701 DEXTER AVENUE N, SEATTLE WA 98109

WEST DESIGN REVIEW BOARD
EARLY DESIGN GUIDANCE
EDG 2 MEETING DATE: 07.10.19
SDCI #: 3033099-EG

NEIGHBORHOOD ECOTONE

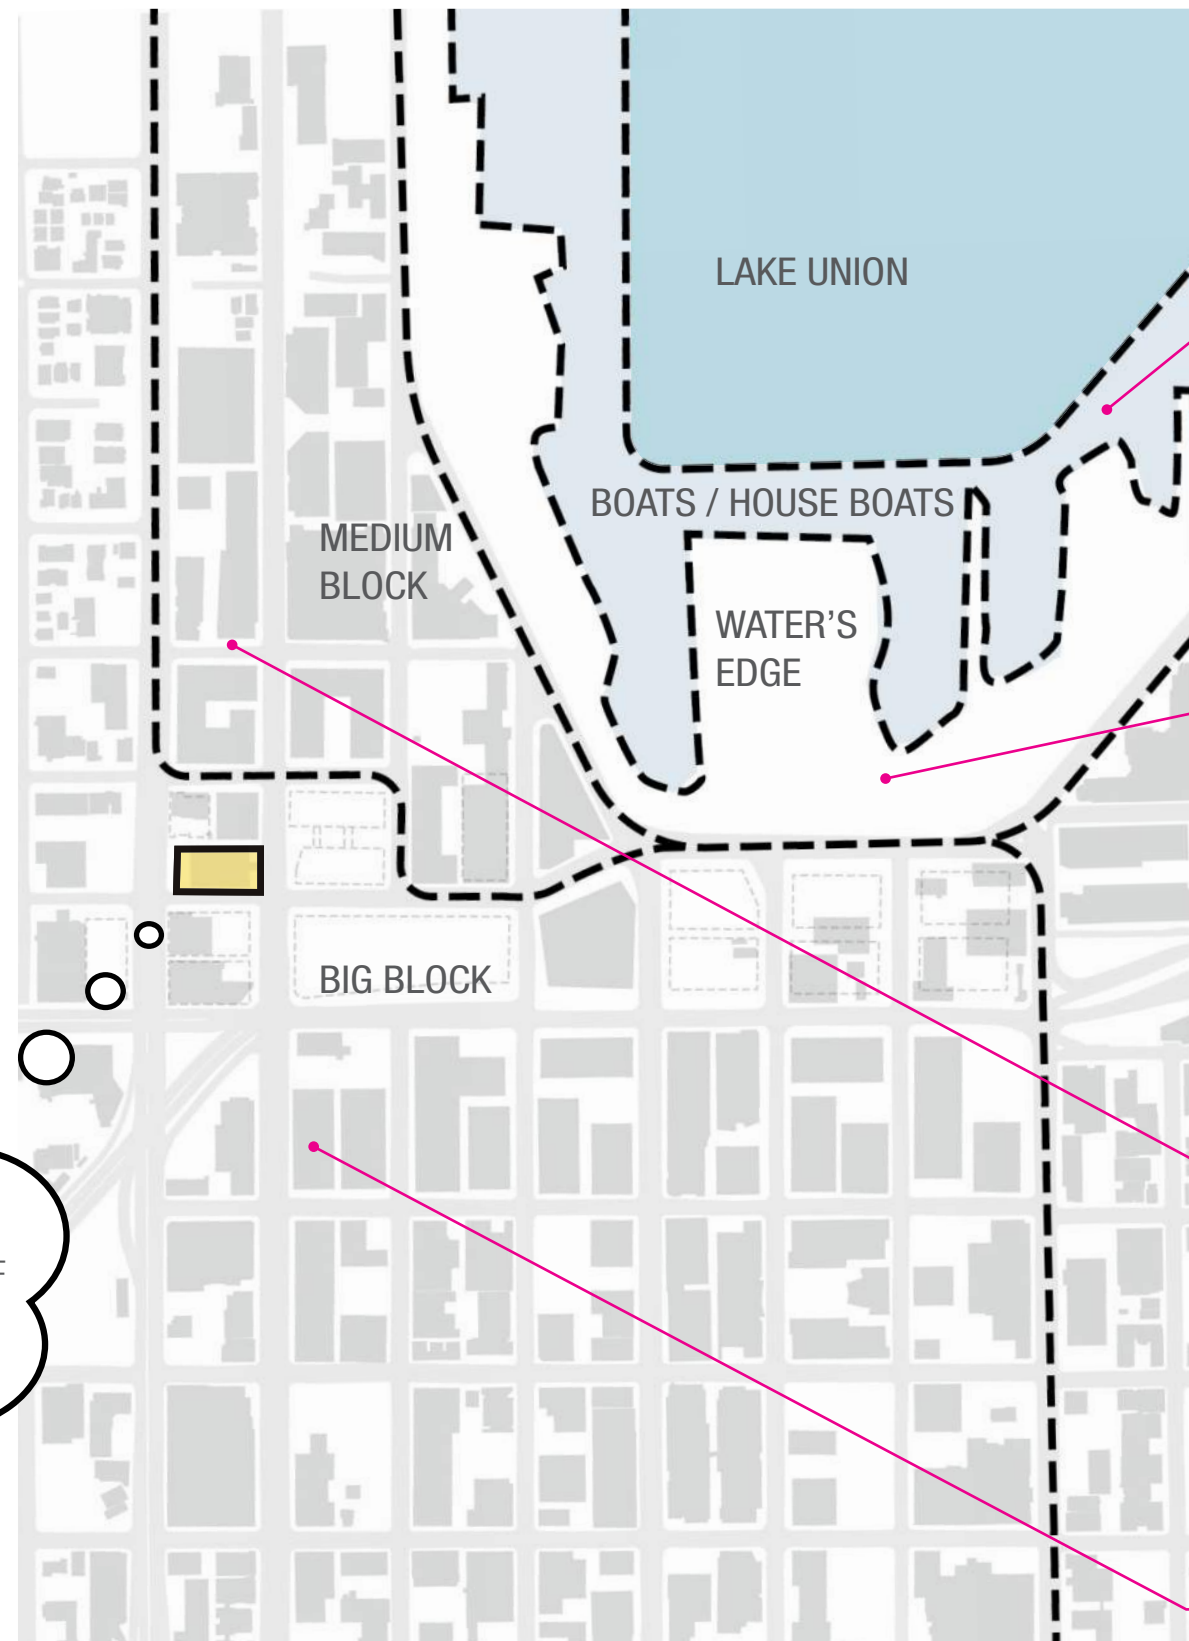
A.2 Address overall height, bulk, modulation, and scale of design as it relates to context and transitional nature of site

A.4 Present a clear concept and note how the massing has evolved

South Lake Union exists as a rich ecotone of various building typologies fronting a marine bay. The building massing scales range from the individual family house boat to a mixed-use commercial high-rise. The vehicular and pedestrian connections also inform how the building masses are perceived from the different streets.

The previous analysis demonstrates the confluence of influences at the nexus of the project site. The proposal seeks to take cues from the rich tapestry of South Lake Union in respect to massing scale and modulation.

03 PROPOSAL | Massing - Review

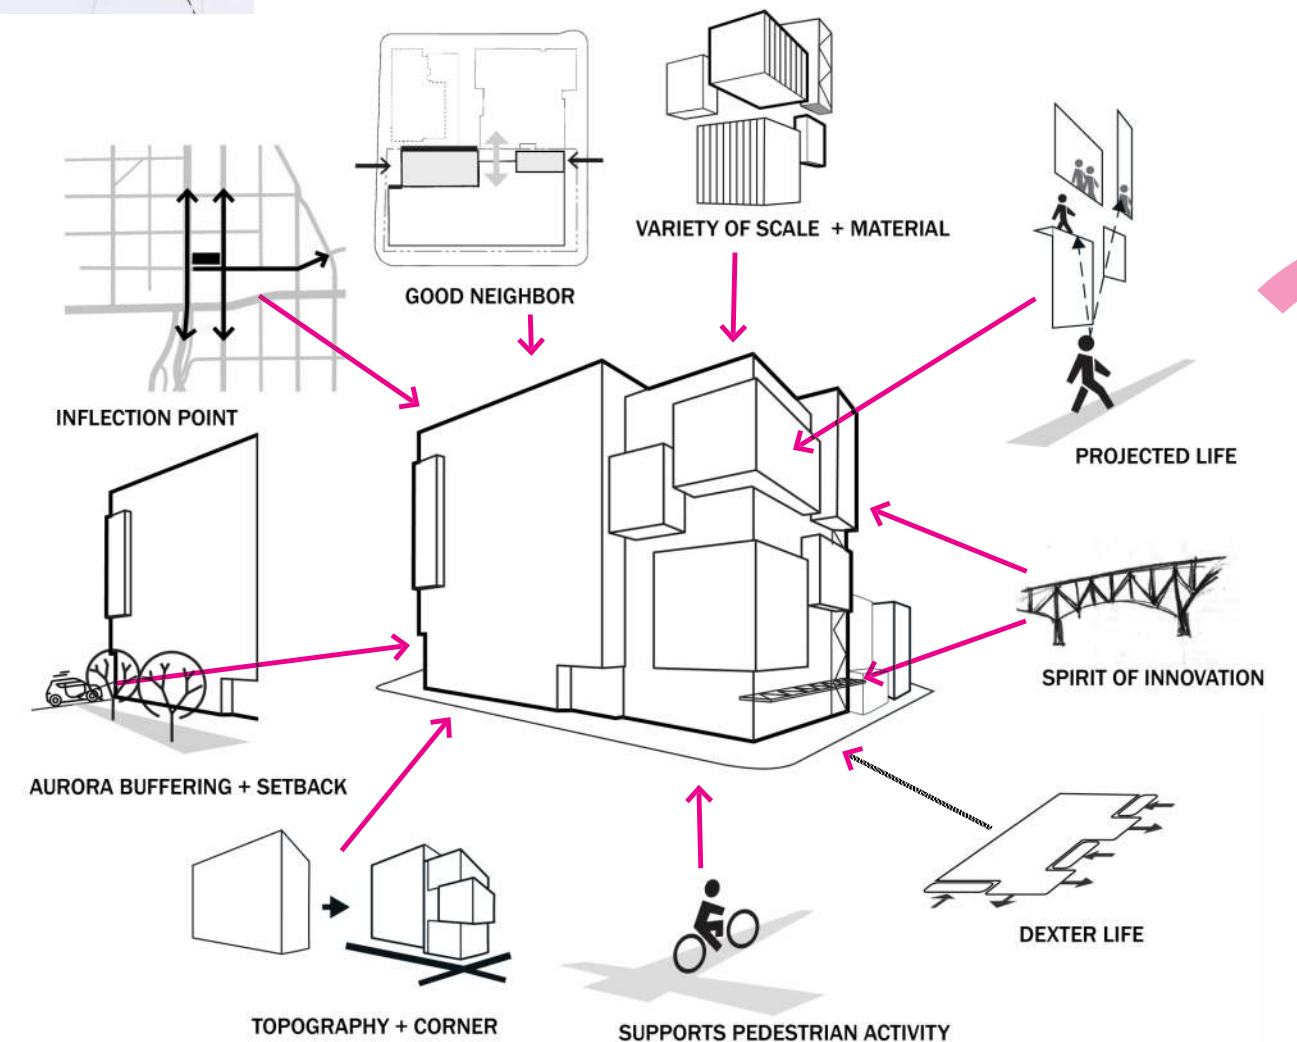
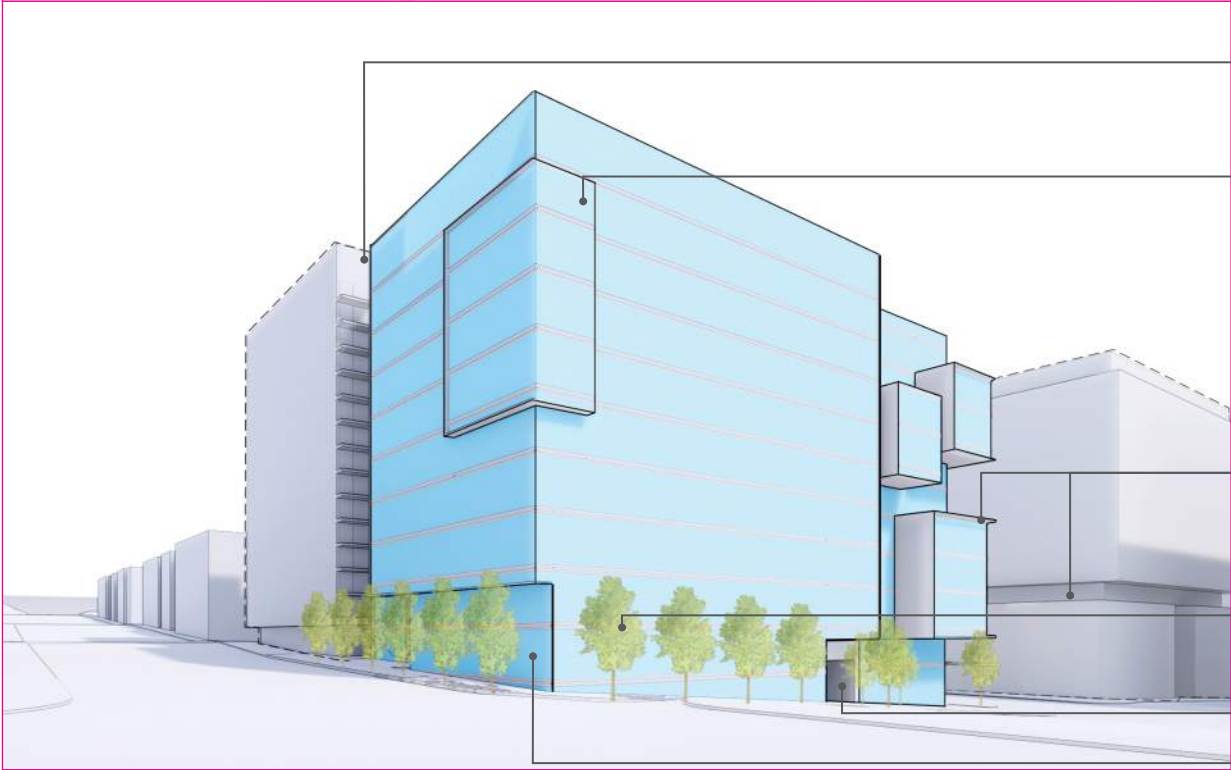
A.2 Address overall height, bulk, modulation, and scale of design as it relates to context and transitional nature of site

A.4 Present a clear concept and note how the massing has evolved

The proposal carefully considers the Tall Building Guidelines, acknowledging the project’s highly visible nature **(DC2-4)**. The revised massing takes cues from these guidelines: we have shaped and oriented floor plates based on context, considered the base scale, street scale, and skyline scale. Modulation is provided to avoid a single repeated extrusion from the base to the top. The scale of modulating volumes create a transition to smaller scales and context to the north.

- Formal concept, including massing split, developed as a response to distinct characteristics of adjacent streets **(CS2-B, DC2)**
- Height, bulk, and scale reduced in response to context **(CS2-D)**
- Height mediated by offsets, projects, intermediate scales, plane changes, depth, and shadows provide human scale and interests **(DC2-4, DC2-C)**
- Transition to smaller scales references existing context along Dexter Ave N **(CS2-D, CS3-A-3, DC2-C)**
- Consideration of three scales; pedestrian, street room, and skyline **(DC2-1)**
- Activated facade at Dexter and Roy establishes a visual gateway, transition, and sets a precedent for the evolving neighborhoods **(CS2-1, CS2-1-A, CS3-A-4)**
- Created open space wrapping primary corner at Dexter and Roy **(PL1-A-2, PL1-B)**

- Setback at NW (hidden from view) to provide daylight access to residential neighbors **(CS2-D)**
- Introduction of modulating element and visual marker at Aurora for massing cohesion and appropriately scaled tower activation at corner **(CS2-3-A, DC2, DC2-1)**
- Activation of facade at tower scale with exterior terraces and contextual references at Dexter Yard and Residential buildings to the north **(CS2-B, CS2-3-A, DC2-4)**
- "Greening" of road-end at Roy to reflect similar contextual conditions at sloping site topography, providing buffer for pedestrian experience **(CS1-C, PL1-B, DC4-D)**
- Minimized vehicular entry visual impact **(DC1-B-1)**
- Setback at ground plane to relieve pinched condition at Aurora **(CS1-C, DC2-4)**

VIEW FROM DEXTER AVE N LOOKING SOUTH

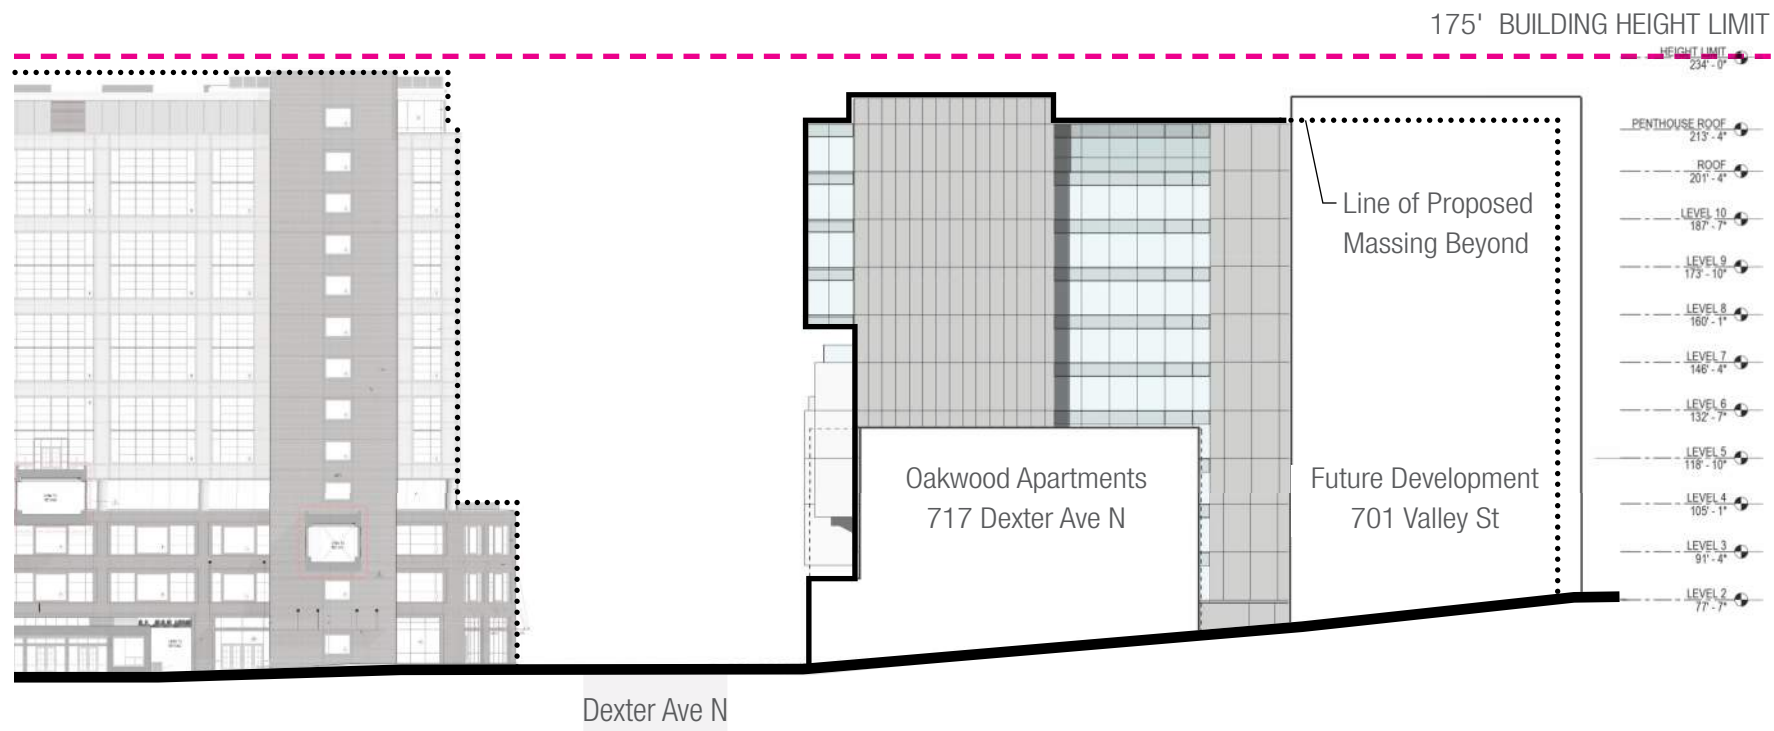
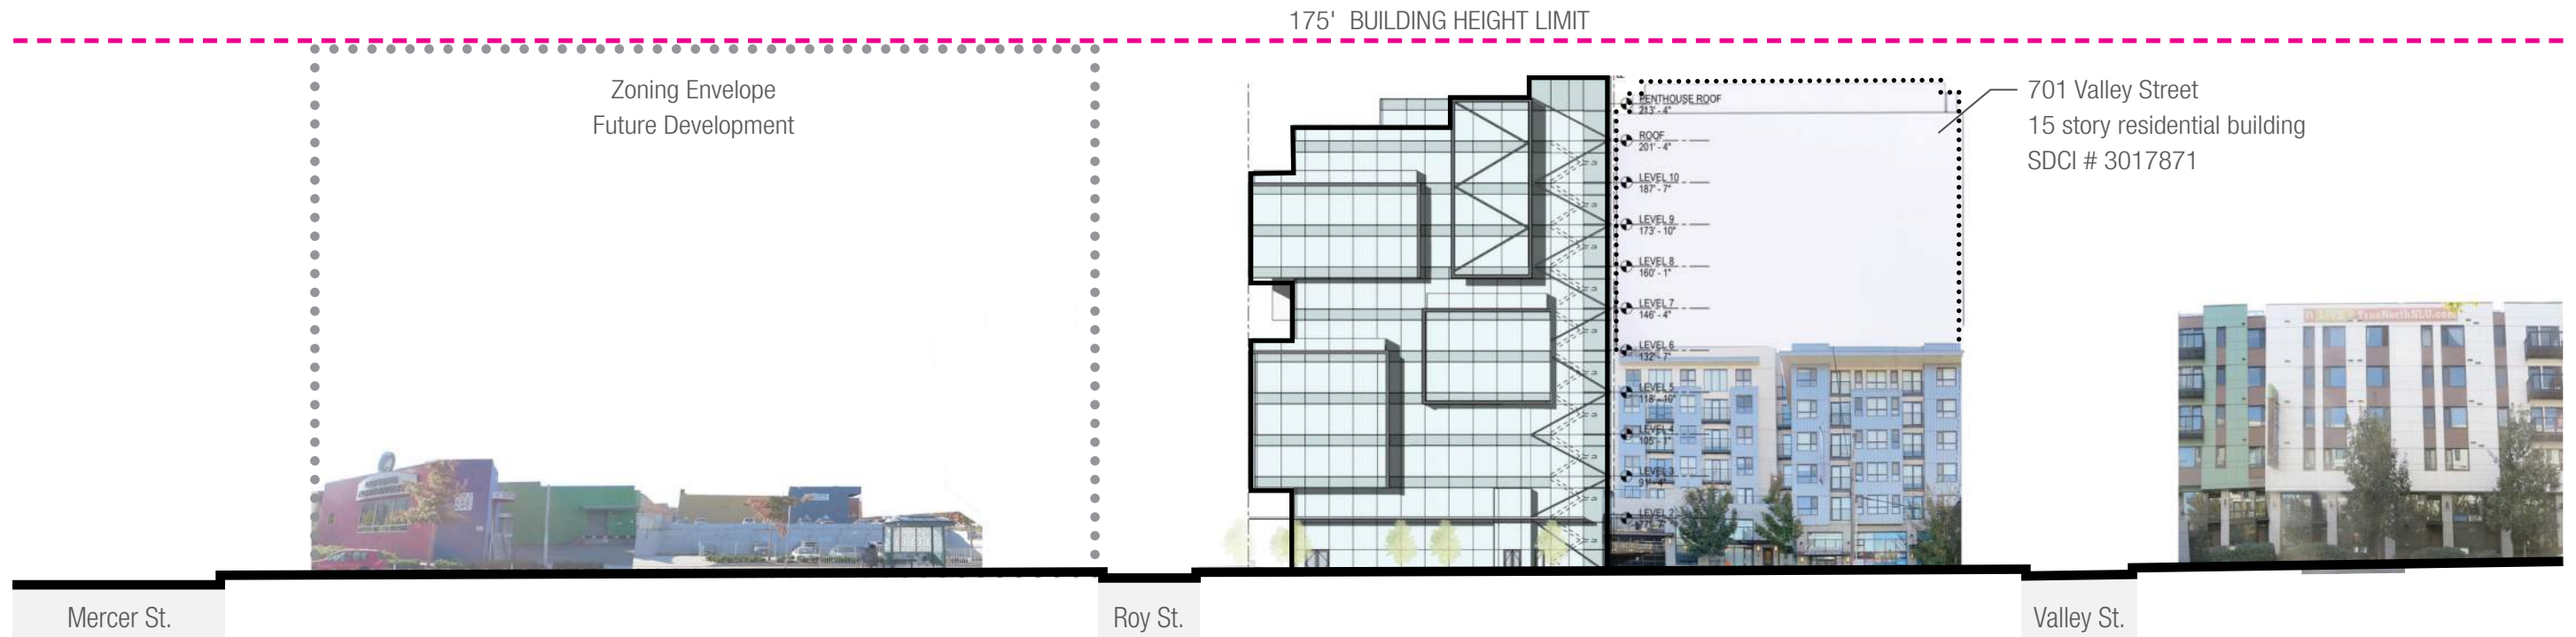
A.2 Address overall height, bulk, modulation, and scale of design as it relates to context and transitional nature of site

A.3 Study how prominent building corners will be viewed moving south and north along Dexter Ave N

B.2 Refine the relationship to the residential structure to the north

The NE stair and elevator massing is setback from Dexter to provide relief to the Oakwood Apt massing at the street wall and allow the smaller projecting volumes to read as transitional scale elements as one approaches the site from the north. The height of the NE stair and elevator massing remains at or below the adjacent heights of roof elements at 701 Valley and 700 Dexter (Dexter Yard.) The proposed north facade is modulated rather than a continuous surface, with setbacks and material changes from opaque to glazed surfaces. Given prominent views to the stair and elevator massing, the proposed design intends to feature enhanced visual interest and detailing. Initial options for integral and applied treatments are proposed on following pages. **(DC2-B)** While not a designated neighborhood gateway, the proposal will serve as a visual gateway moving into downtown, as one leaves predominantly residential areas. As described in **CS2-1**, the massing and visual treatment will become a physical marker so that the community understands this as an approach and transition to an area of distinct character.

03 PROPOSAL | Massing Concept - Views

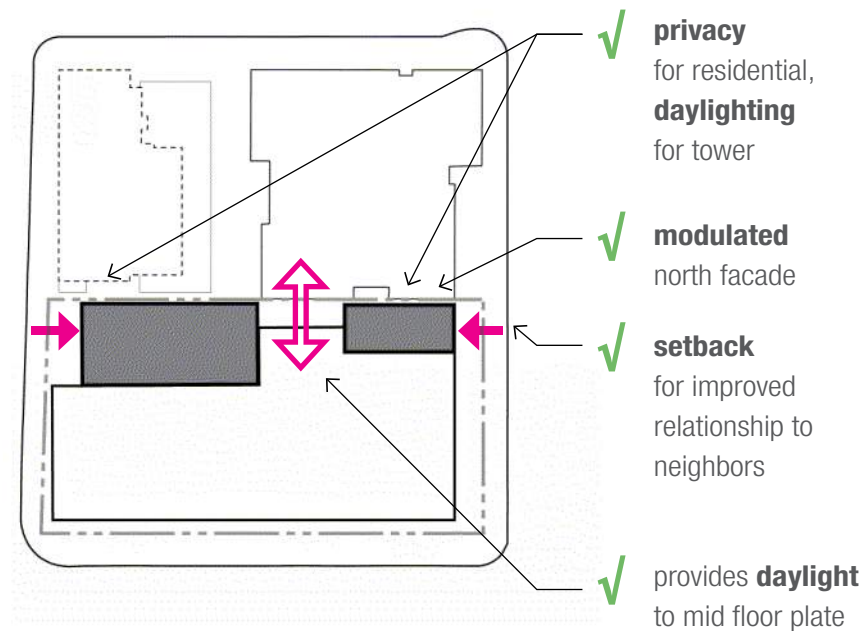
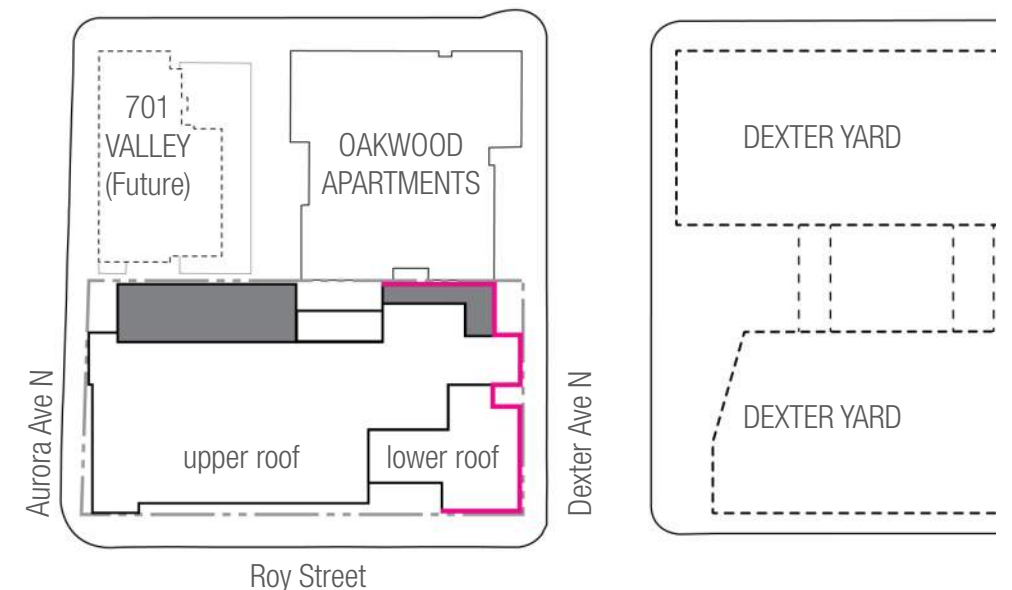
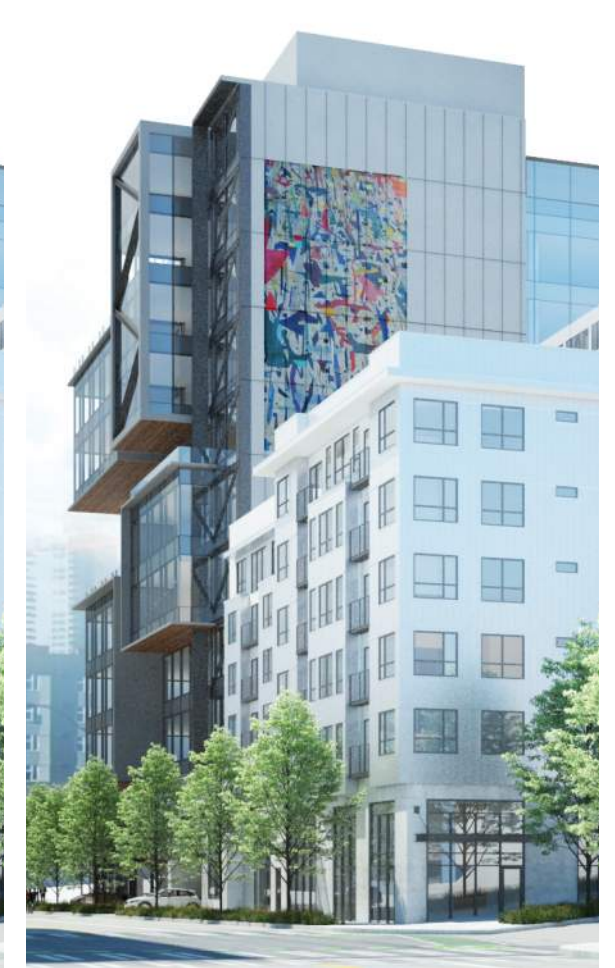
A.3 Study how prominent building corners will be viewed moving south and north along Dexter

The board indicated support for the northern core placement and modulated north facade. This placement is meant to support both privacy for residential uses to the north and modulation of the north facade (**DC2-4**). A setback at the NW corner provides additional daylight access to residential openings planned at the new 701 Valley development. The proposed massing sets back the stair and elevator tower at the NE corner to align with the main upper massing of the Oakwood Apt building, to permit additional daylight access to their rooftop amenity space, and to allow a clear reading of projected volumes activating Dexter Ave from the north. This setback reduces the massing bulk at the NE street lot line.

The projecting volumes shift down at the Roy-Dexter intersection to more directly address this primary corner, reduce bulk, and provide continuity with street-level datums from the north. These smaller scale massing elements create visual markers as one moves to the north.
